KWM-380 TRANSCEIVER (622-5093-001, -101)
HF-380 TRANSCEIVER (622-3580-001, -101)

SERVICE BULLETIN NO 6

CORRECT TRANSMIT HUM

KWM-380/HF-380 Front Panel, Rear View
Figure 1

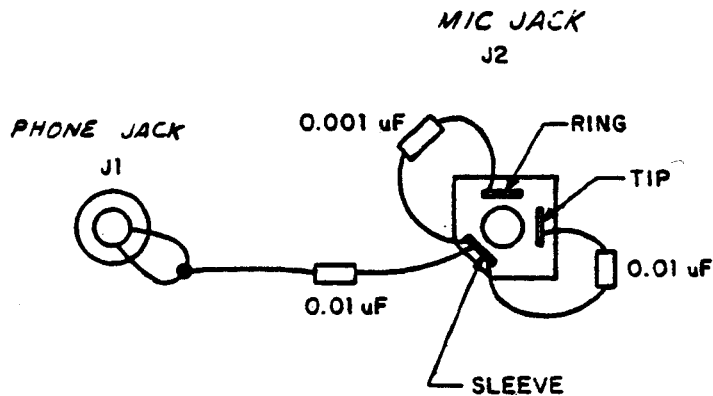
- C. Unsolder and remove the wires connected to mic jack J2 (figure 1).
- D. Remove and discard J2 by removing the nut that secures the jack to the front panel. Discard the bypass capacitors mounted on the jack.
- E. Install a new jack (647-2739-001) with the orientation shown in figure 2 using a black nut (334-1657-020).

Mic Jack J2, Orientation Diagram
Rear View of Front Panel
Figure 2

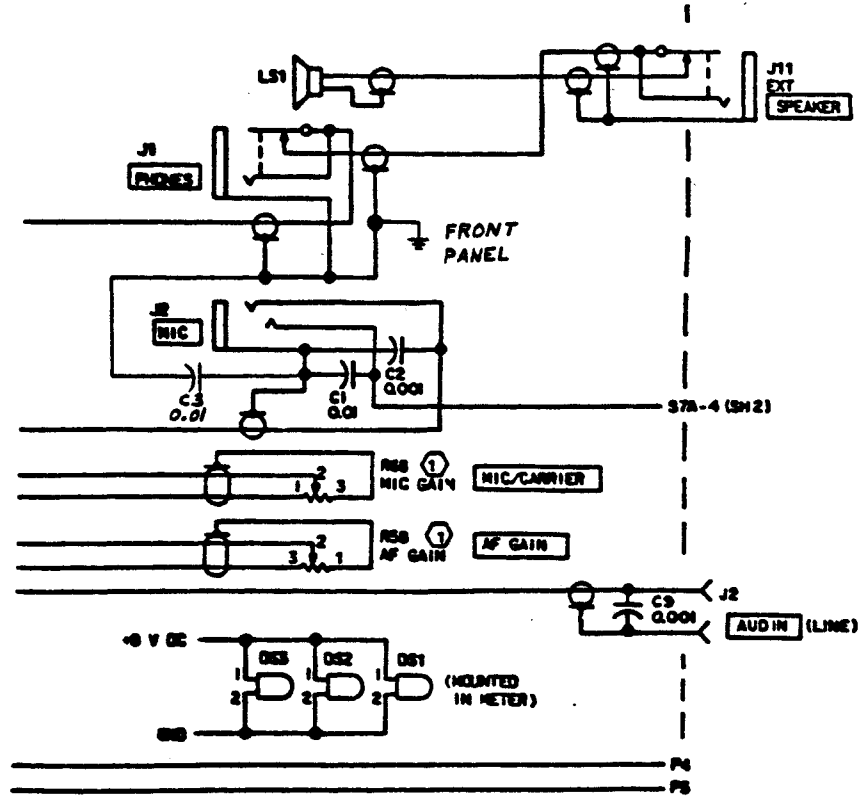
NOTE: Refer to figure 2 while performing steps F through J.

- F. Install 0.01 uF capacitor C1 (913-3331-020) between J2 tip and sleeve.
- G. Install 0.001 uF capacitor C2 (913-3331-010) between J2 ring and sleeve.
- H. Install 0.01 uF capacitor C3 (913-3331-020) between J2 sleeve and J1 sleeve (front panel ground).
- I. Reconnect the blue wire (removed in step C) to J2 tip.
- J. Reconnect the shielded cable white wire to J2 ring and black wire to J2 sleeve.
